FHWA REG NO.	STATE	PROJECT NO.	YEAR	SHEET NO.	TOTAL SHEETS
7	KANSAS	STP-N012(901)	1999	42	131

KANSAS DEPARTMENT OF TRANSPORTATION
448-89404
PAWNEE AVENUE
E. of Rock to WEBB
WATER LINE RELOCATION

PLAN - MAIN 4
SCALE: 1 : 500

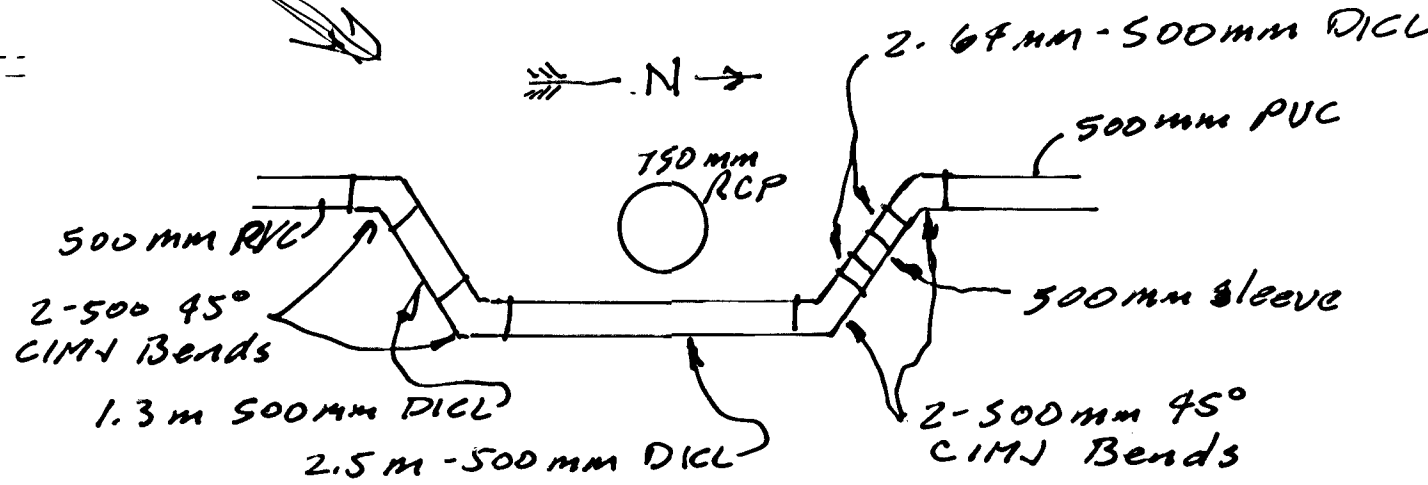
Added Waterline Correction
@ Sta. 4+723.57, 14.0'm Rt
(to accomodate SWS Revision)
